ADDENDUM NO. 1

To: All Planholders
From: Antonio L. Reyna, PE
Subject: Harlingen Economic Development Corporation
The Park at Roosevelt – EDA Grant Project
Date: August 30, 2024

- I. Replace Plan Sheets 3, 9 and 10 with attached Revised Plan Sheets 3, 9 and 10, Addendum No. 1, dated 8/30/2024.

HARLINGEN ECONOMIC DEVELOPMENT CORPORATION
 THE PARK AT ROOSEVELT - EDA GRANT PROJECT
 CONSTRUCTION PLANS
 STORM WATER POLLUTION PROTECTION PLAN

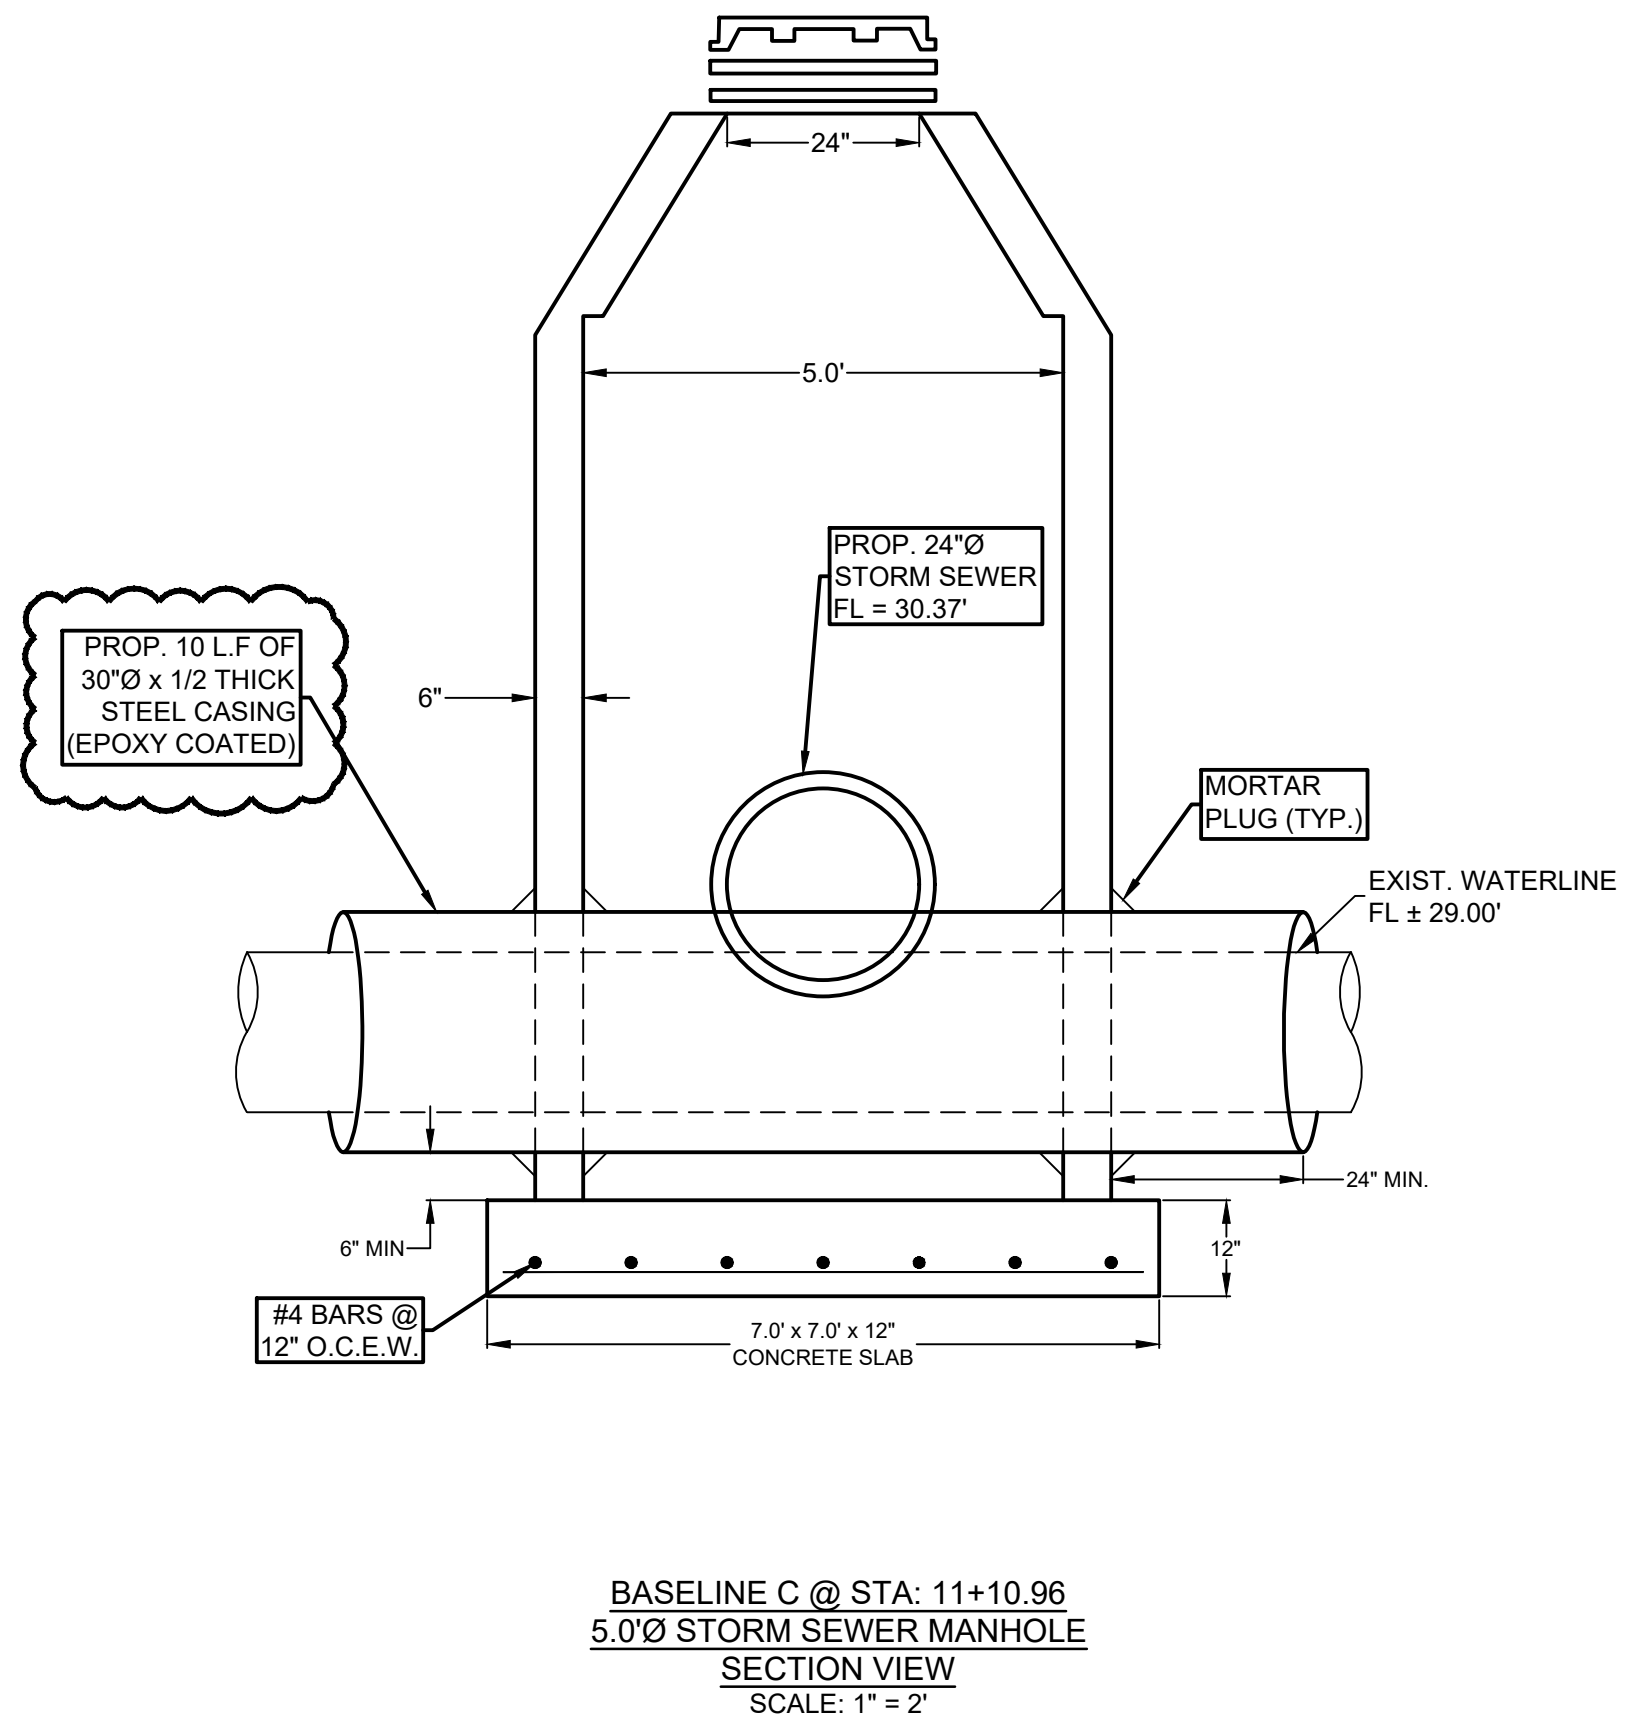
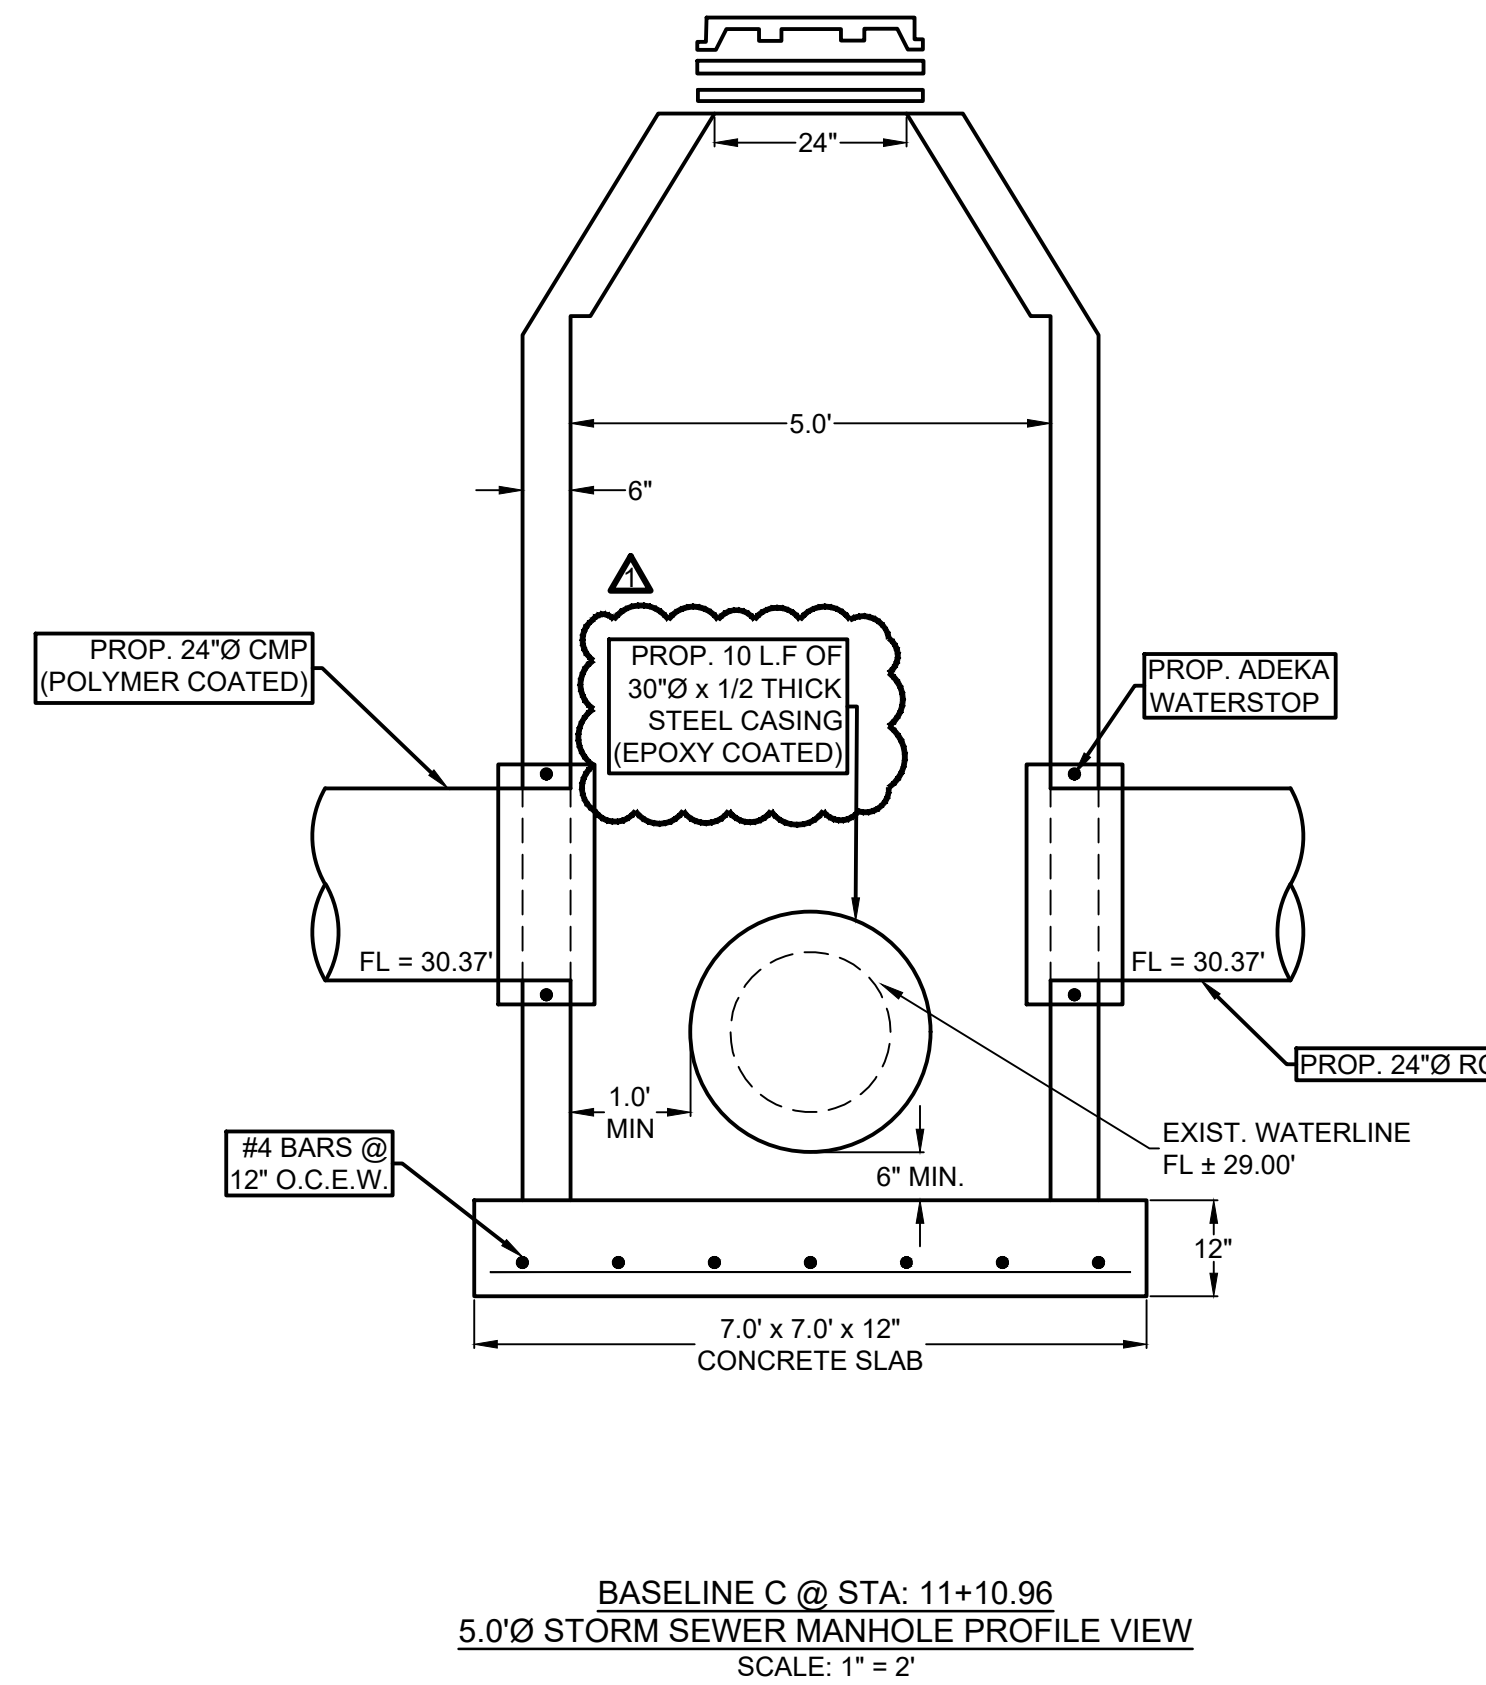
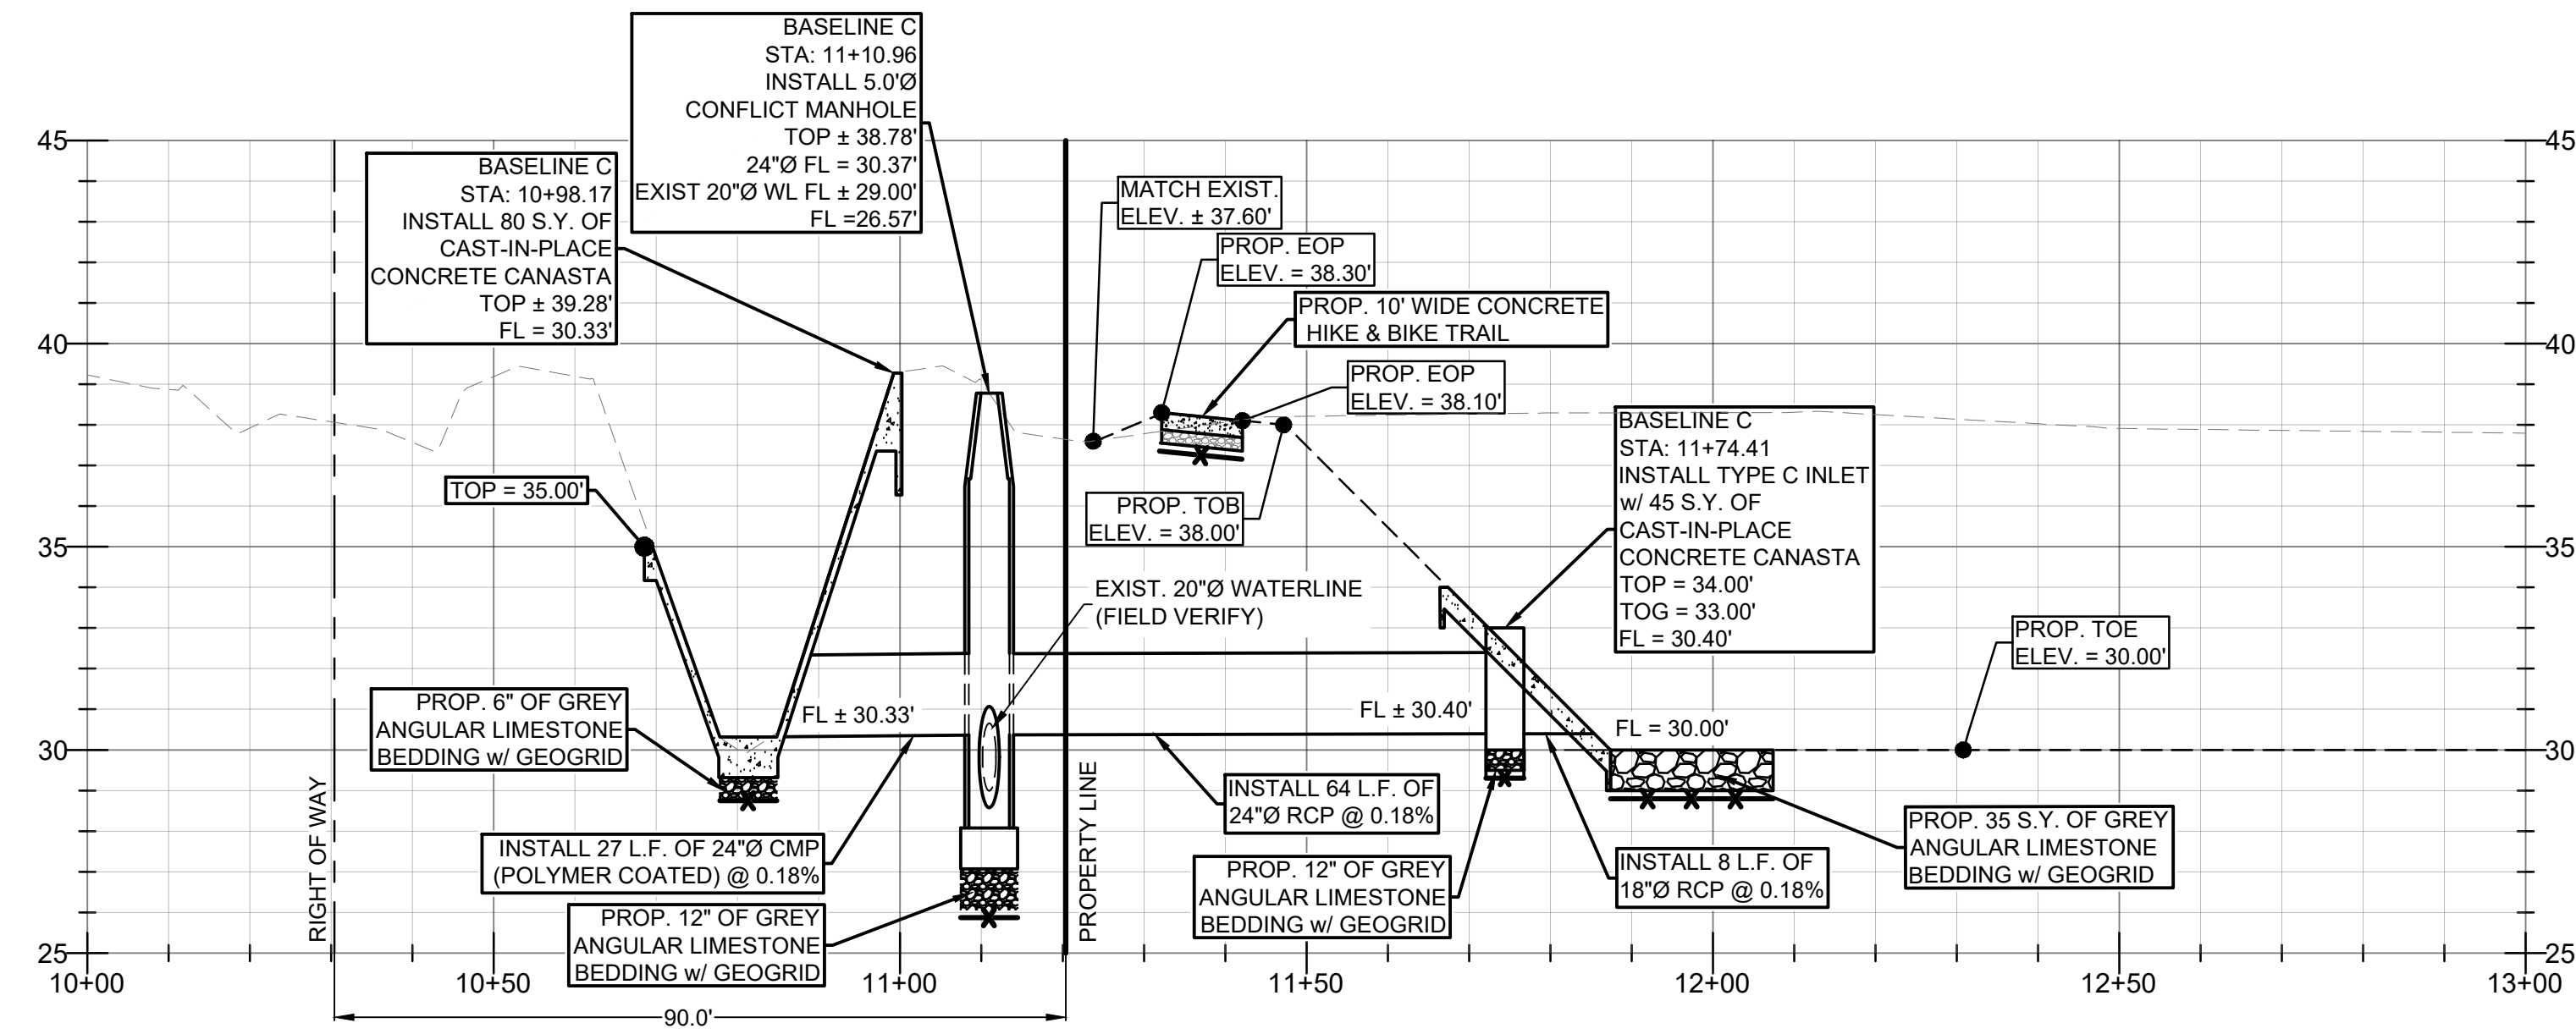
REVISIONS:
08/30/2024
ADDENDUM NO. 1
ADD SPOILS AREA
